Access Compliance Report Public Rights-of-Way (Curb Ramps)

Main Street: LA_LOMA_DR Cross Street: LOMA_LINDA_WAY Location: SW

ADA ID: RPRK211012124835 Ramp Type: Type 4 - Parallel Initial Pass/Fail: Pass Overall Compliance: No Severity Score: 20

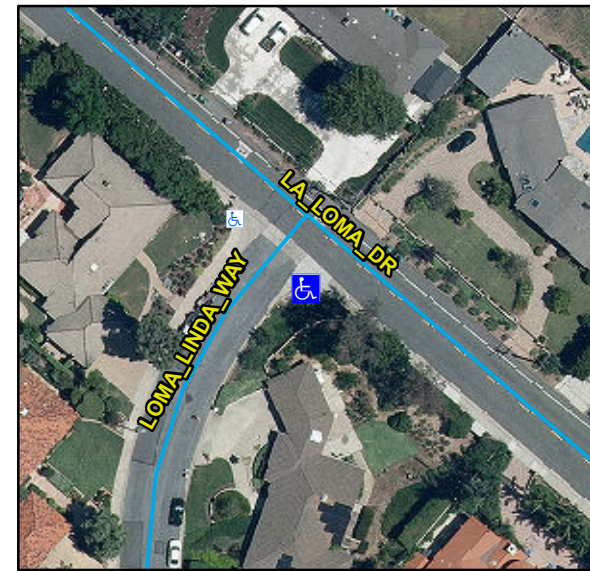
Compliance	Description	Data	Compliance	Description	Data
N/A	Ramp Length LT (in)	128	N/A	Ramp Length RT (in)	136
Yes	Ramp Width LT (in)	62	Yes	Ramp Width RT (in)	72
Yes	Ramp Run Slope LT (%)	4.6	Yes	Ramp Run Slope RT (%)	7.6
Yes	Ramp Cross Slope LT (%)	0.9	Yes	Ramp Cross Slope RT (%)	0.2
N/A	Landing Present	No	No	DWS Provided	No
N/A	Landing Length (in)	N/A	N/A	DWS Contrast	N/A
No	Landing Width (in)	N/A	N/A	DWS Length (in)	N/A
No	Landing Run Slope (%)	N/A	N/A	DWS Full Width	N/A
No	Landing Cross Slope (%)	N/A		DWS Offset Type	N/A
N/A	Landing Movement Obstructed?	No	N/A	DWS Offset Left (in)	N/A
	Landing Movement Type	Curb	N/A	DWS Offset Right (in)	N/A
N/A	Landing Shared	N/A			
N/A	Clear Space	Yes			
N/A	Clear Space To Crosswalk (in)	48			
N/A	Marked Crosswalk 1	No	N/A	Marked Crosswalk 2	No
	Crossing 1 Direction	NE		Crossing 2 Direction	NW
	Marked Crosswalk 1 Width (in)	N/A		Marked Crosswalk 2 Width (in)	N/A
N/A	Ramp Inside Crosswalk 1	N/A	N/A	Ramp Inside Crosswalk 2	N/A

Crossing 1 Slope (%)	6.9		Crossing 2 Slope (%)	1
	Crossing 1 Cross Slope (%)	1.2		Crossing 2 Cross Slope (%)	2.7
Yes	Gutter Ponding	No	Yes	Curb Slope	2.3
Yes	Gutter Lip Height (in)	0		Road Run Slope (%)	0.8
Yes	Gutter Run Slope (%)	3.5		Road Cross Slope (%)	2.8
Yes	Gutter Cross Slope (%)	0.5	No	Perpendicular Joint Present	No
Yes	Overall Surface Condition	Acceptable			
	Cross Gutter Present?	Yes		Spandrel Present?	Yes
	Replace Cross Gutter?	No		Replace Spandrel?	No

Remove & Replace Curb Ramp With Two New Directional Ramps or Equivalent.
